Access Compliance Report

Public Rights-of-Way

(Curb Ramps)

Intersection ID: 14356	Main Street: BAXTER_ST	Cross Street: S_TORRENCE_ST	Location: S
ADA ID: C0E672CD3C7D	Ramp Type: PerpDiag	Initial Pass/Fail: Fail	Overall Compliance: No
		Severity Score: 37.5

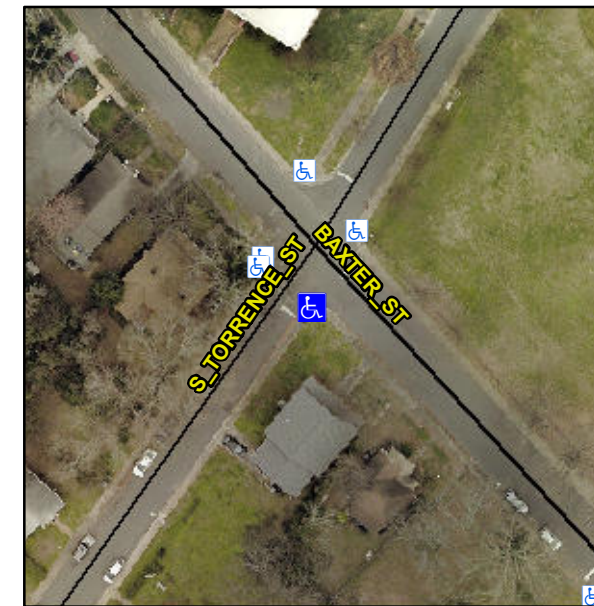
R304.2.2, R304.5.3

Compliance	Description	Data	Compliance	Description	Data
N/A	Ramp Length (in)	53.0	No	Ramp Slope (%)	15.4
Yes	Ramp Width (in)	48.0	No	Ramp XSlope (%)	5.8
N/A	Flare Type LT	N/A	N/A	Flare Type RT	N/A
N/A	Flare Slope LT (%)	N/A	N/A	Flare Slope RT (%)	N/A
N/A	Flare Traversable LT?	N/A	N/A	Flare Traversable RT?	N/A
N/A	Landing Length (in)	N/A	N/A	DWS Provided?	N/A
N/A	Landing Width (in)	N/A	N/A	DWS Contrast?	N/A
N/A	Landing Slope (%)	N/A	N/A	DWS Length (in)	N/A
N/A	Landing X Slope (%)	N/A	N/A	DWS Full Width?	N/A
N/A	Landing Curb? (Y/N)	N/A	N/A	DWS Offset (in)	N/A
N/A	Shared Landing?	N/A			
N/A	Gutter Ponding?	N/A	N/A	Gutter Slope (%)	N/A
N/A	Gutter Lip Ht (in)	N/A	N/A	Gutter X Slope (%)	N/A
N/A	Painted X Walk1?	No	N/A	Painted X Walk2?	No
	X Walk 1 Direction	To NE		X Walk 2 Direction	To NW
N/A	X Walk 1 Width (in)	N/A	N/A	X Walk 2 Width (in)	N/A
	X Walk 1 Slope (%)	5.3		X Walk 2 Slope (%)	0.5
	X Walk 1 X Slope (%)	2.0		X Walk 2 X Slope (%)	6.3

Remove & Replace Curb Ramp With Two New Directional Ramps or Equivalent.
